## Metal Junction Box Grounding Instructions

<b>Bulletin Type:</b>	Recall	<b>Publication Date:</b>	March 2022
<b>Bulletin #(s):</b>	22V-054 US_2022-048 CAN	<b>Make(s):</b>	Jayco
<b>Job Code(s):</b>	9901574	<b>Model(s):</b>	Eagle FW
<b>Flat Rate(s):</b>	.50 / Hour	<b>Model Year(s):</b>	2022

<b>Incident:</b>	Metal junction box was not grounded
<b>Affected Units:</b>	2022 Jayco Eagle FW
<b>Parts List:</b>	<b>Parts List: (Purchase locally)</b> - MN cable (Copper Wire)
	<b>Parts Kit Contents: None</b>
<b>Misc. Tools &amp; Supplies:</b>	- Flathead Screwdriver - Wire Pliers/strippers

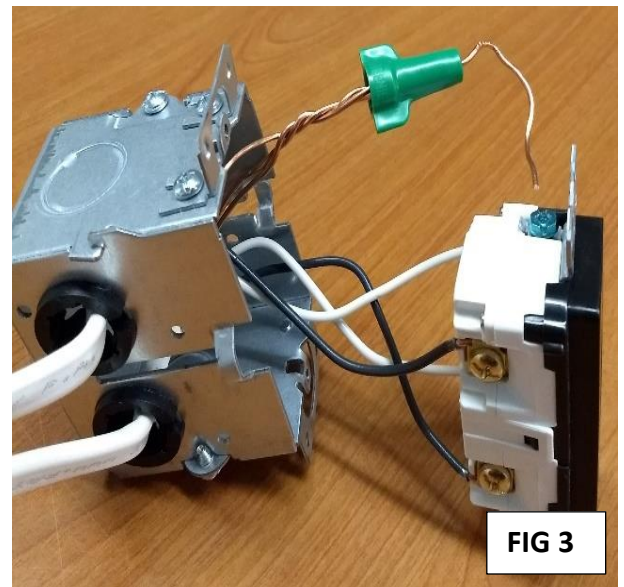
1. Disconnect unit from the 120V power source
2. Locate metal junction box with a GFCI receptacle at the Kitchen.
3. Remove faceplate and receptacle (Fig. 1) to expose wires.

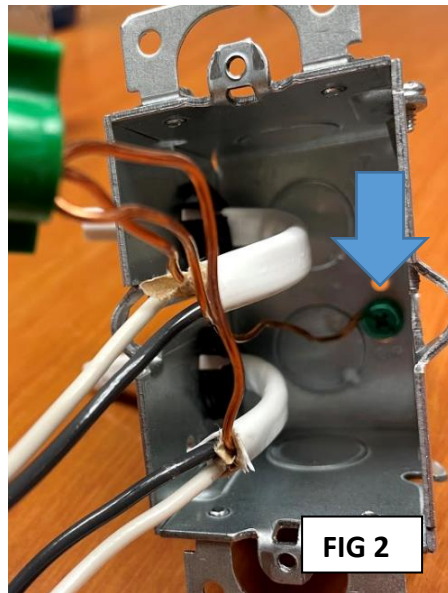
4. Install and secure a separate bare ground wire of sufficient length at the green ground screw (Blue Arrow) in the metal junction box (Fig 2).

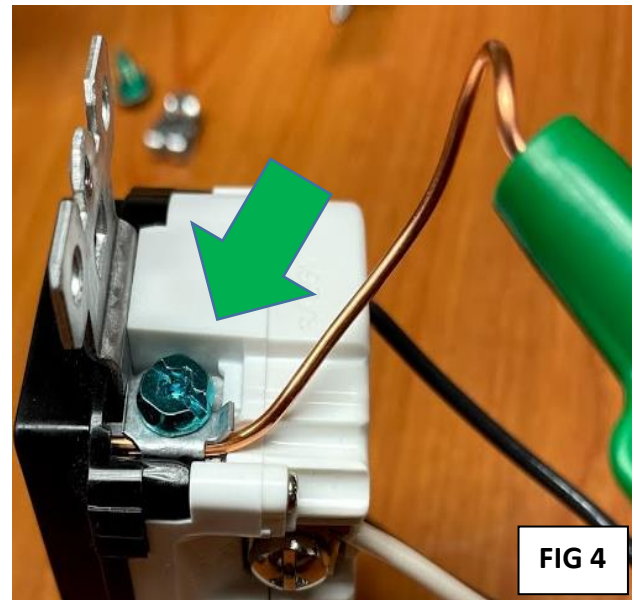
5. Connect all ground wires together with green wire nut. Ensure the bare ground wire attached to the box passes through the hole in the top of the green wire nut (Fig 3).
6. Connect the bare ground wire coming through the top of the wire nut to the green ground screw (Green Arrow) on the GFCI receptacle (Fig 4).
7. Insert wires back into the metal junction box.
8. Secure GFCI receptacle and outlet face plate to junction box.
9. Turn power back on and validate function of the GFCI receptacle.
10. Repair is complete.
